HISTORIC AND DESIGN REVIEW COMMISSION

HDRC CASE NO: 2021-620
ADDRESS: 124 N MAIN AVE
110 E HOUSTON ST
131 SOLEDAD ST
LEGAL DESCRIPTION: NCB 133 ALL OF BLK
NCB 909 BLK LOT 18
ZONING: D, HL, RIO-3
CITY COUNCIL DIST.: 1
DISTRICT: Main/Military Plaza Historic District
LANDMARK: Rand Building, Individual Landmark
APPLICANT: Beverly Baldwin/Alamo Architects
OWNER: Katherine Fontenot/RAND BUILDING LTD
TYPE OF WORK: Exterior modifications, storefront modifications
APPLICATION RECEIVED: November 29, 2021
60-DAY REVIEW: Not applicable due to City Council Emergency Orders
CASE MANAGER: Edward Hall

Rand Garage Tenant Shell Scope of Work Narrative

EXTERIOR
ELEVATIONS -
GARAGE

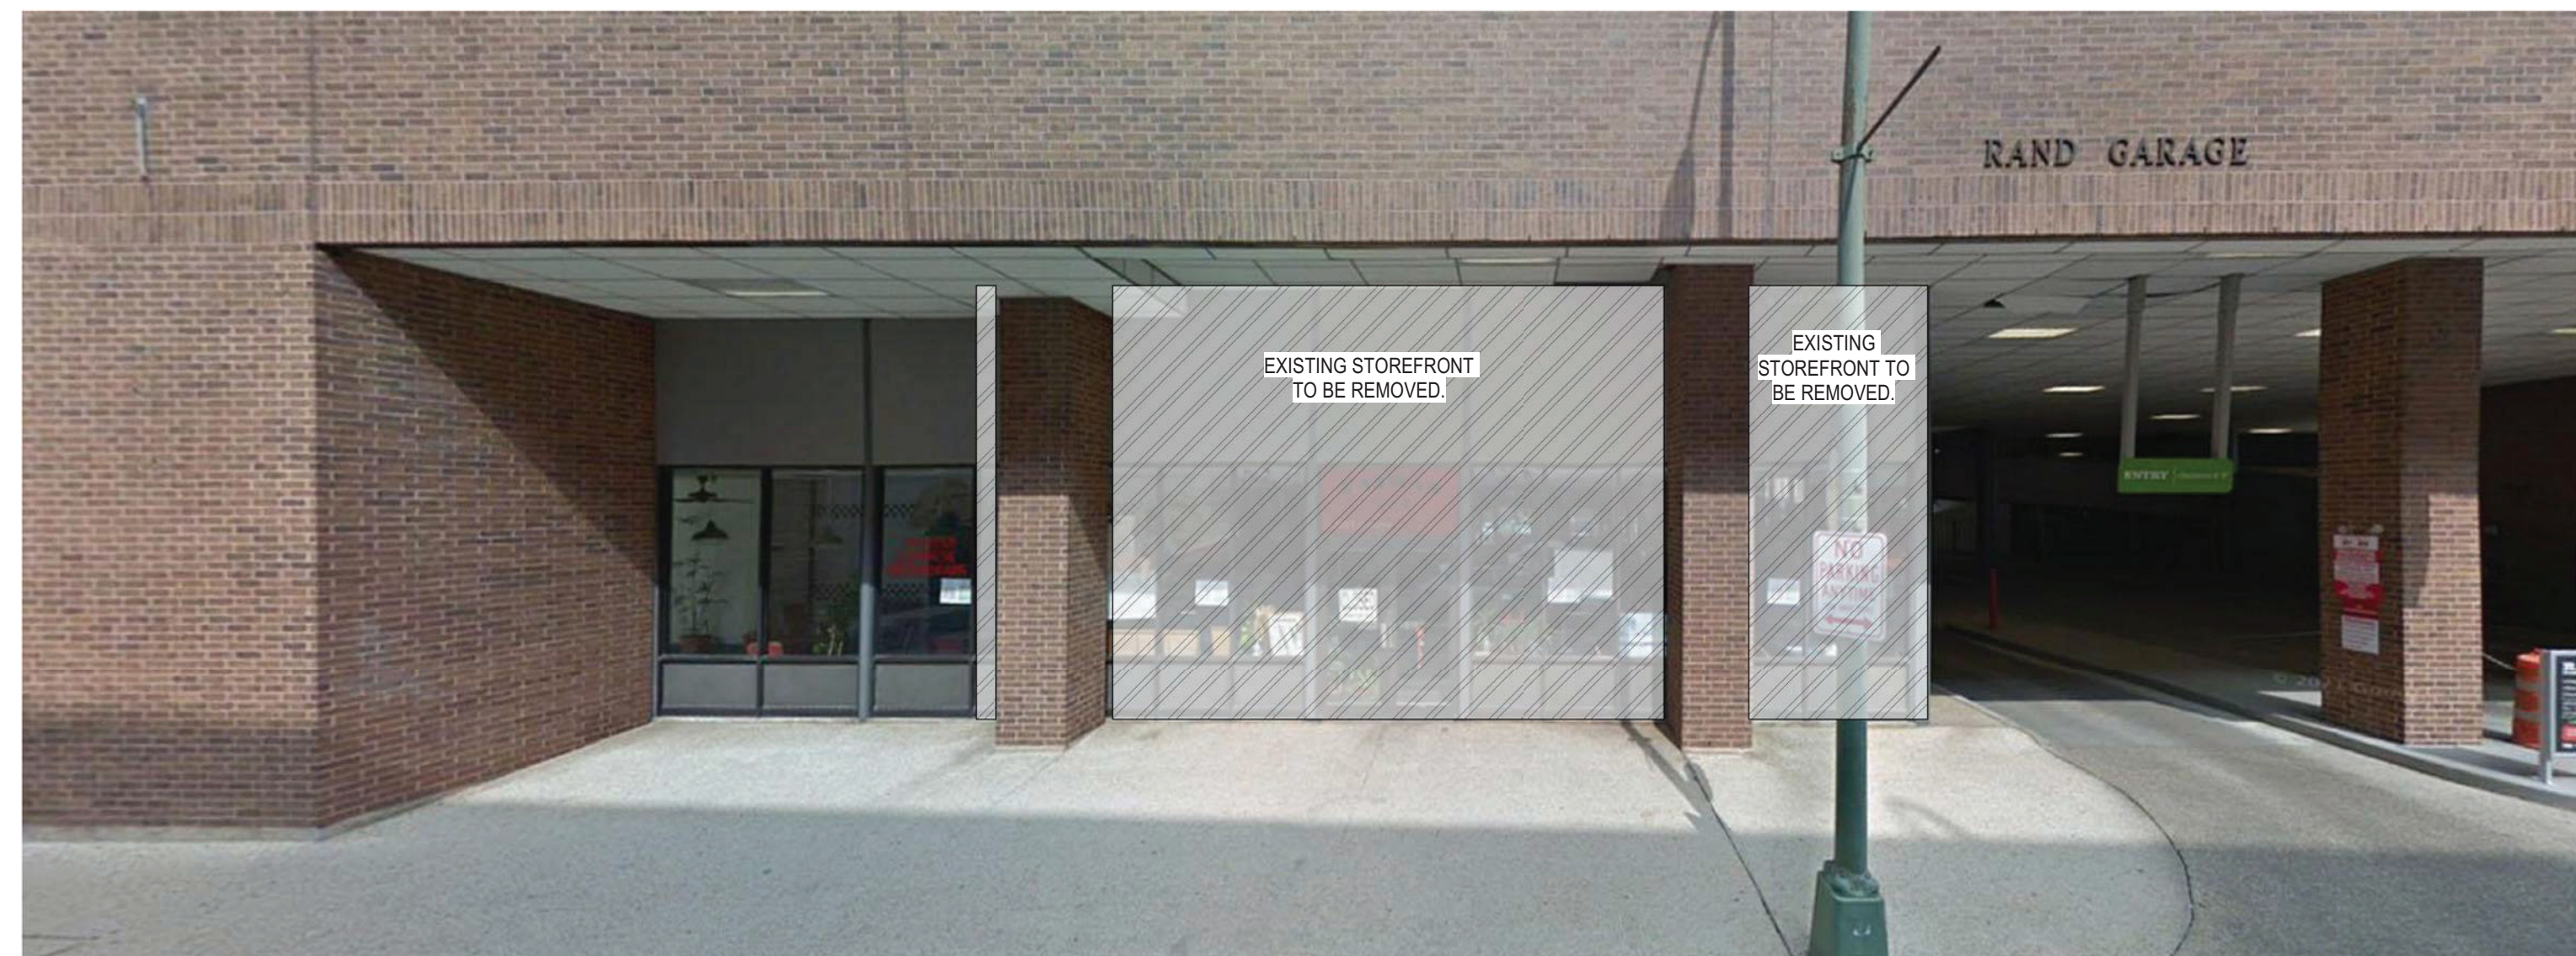
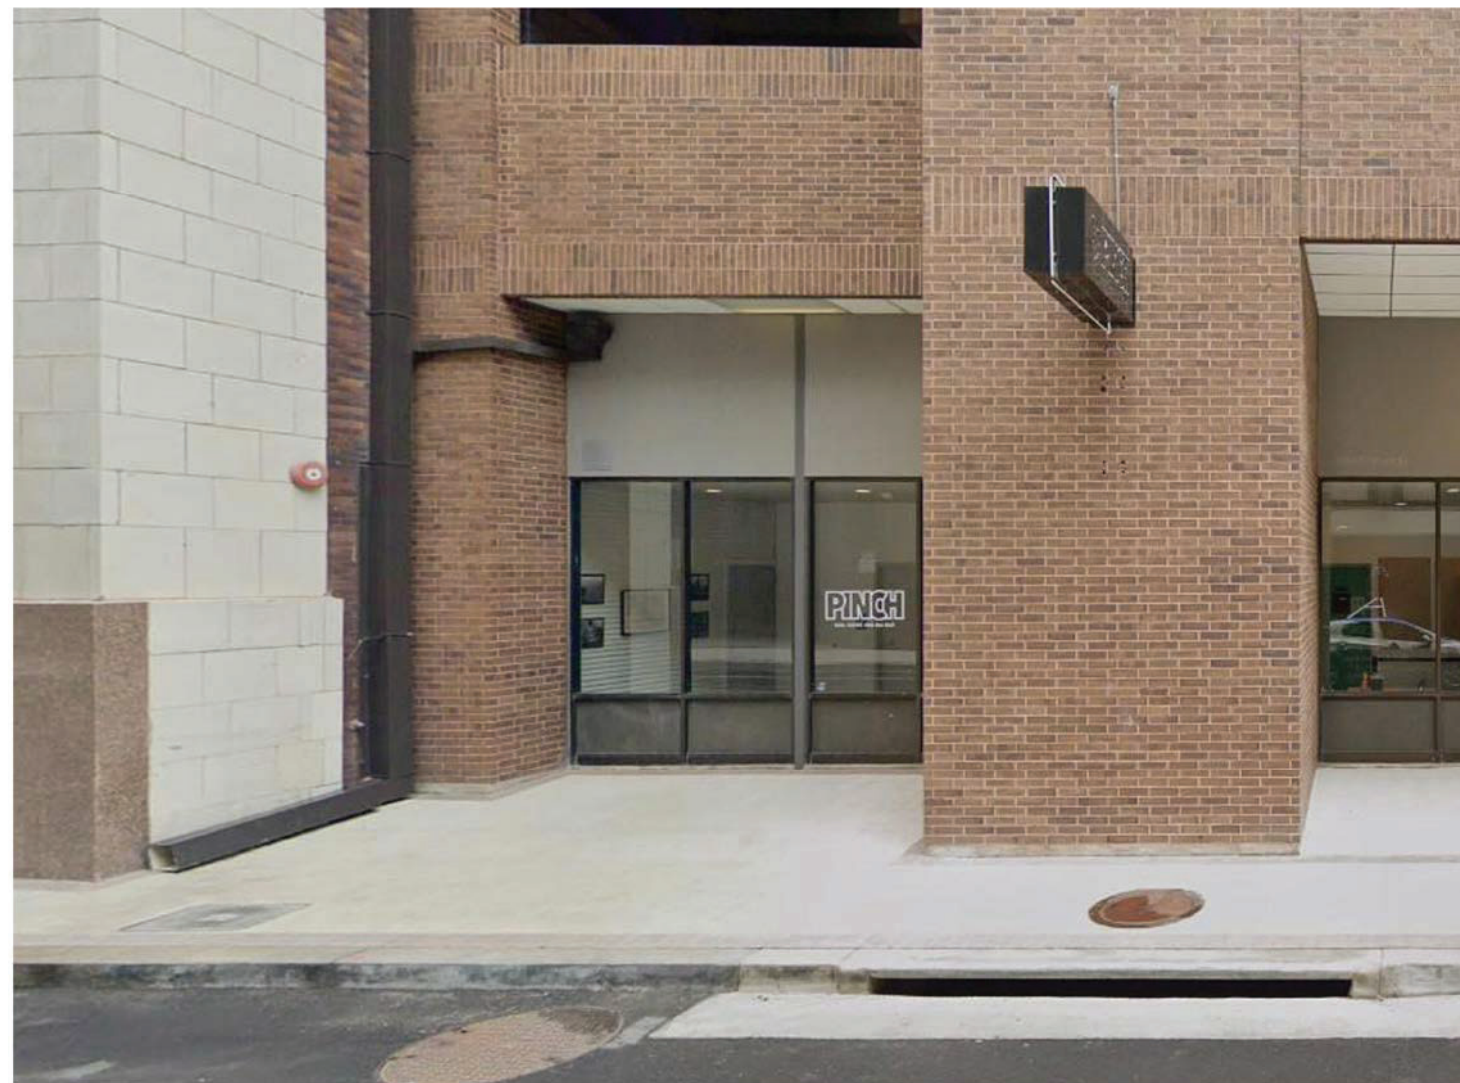
- d. GARAGE STOREFRONT MODIFICATIONS – The applicant has proposed to modify the storefront system within the existing parking garage on N Main façade by reducing the amount of conditioned space. The applicant has also proposed modifications within the footprint of the garage to both the storefront system and drive thru. Staff finds the proposed modifications to be appropriate.
